Access Compliance Report

Public Rights-of-Way

Intersection ID: 42705	Main Street: PARK_RD	Cross Street: SHARON_RD	Location: SE
ADA ID: CC2E849D4F3C	Ramp Type: Perp	Initial Pass/Fail: Fail	Overall Compliance: No
		Severity Score: 12.5

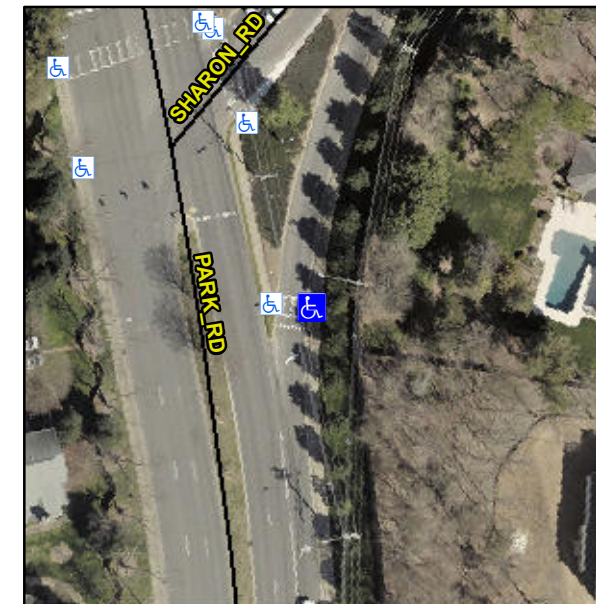
Not Found, R304.2.2

Compliance	Description	Data	Compliance	Description	Data
N/A	Ramp Length (in)	61.0	No	Ramp Slope (%)	9.6
Yes	Ramp Width (in)	48.0	Yes	Ramp XSlope (%)	0.5
N/A	Flare Type LT	N/A	N/A	Flare Type RT	N/A
N/A	Flare Slope LT (%)	N/A	N/A	Flare Slope RT (%)	N/A
N/A	Flare Traversable LT?	N/A	N/A	Flare Traversable RT?	N/A
N/A	Landing Length (in)	N/A	N/A	DWS Provided?	N/A
N/A	Landing Width (in)	N/A	N/A	DWS Contrast?	N/A
N/A	Landing Slope (%)	N/A	N/A	DWS Length (in)	N/A
N/A	Landing X Slope (%)	N/A	N/A	DWS Full Width?	N/A
N/A	Landing Curb? (Y/N)	N/A	N/A	DWS Offset (in)	N/A
N/A	Shared Landing?	N/A			
N/A	Gutter Ponding?	N/A	N/A	Gutter Slope (%)	N/A
N/A	Gutter Lip Ht (in)	N/A	N/A	Gutter X Slope (%)	N/A
N/A	Painted X Walk1?	Yes	N/A	Painted X Walk2?	N/A
	X Walk 1 Direction	To NW		X Walk 2 Direction	N/A
N/A	X Walk 1 Width (in)	109.0	N/A	X Walk 2 Width (in)	N/A
	X Walk 1 Slope (%)	1.9		X Walk 2 Slope (%)	N/A
	X Walk 1 X Slope (%)	1.7		X Walk 2 X Slope (%)	N/A

Remove & Replace Entire Ramp.
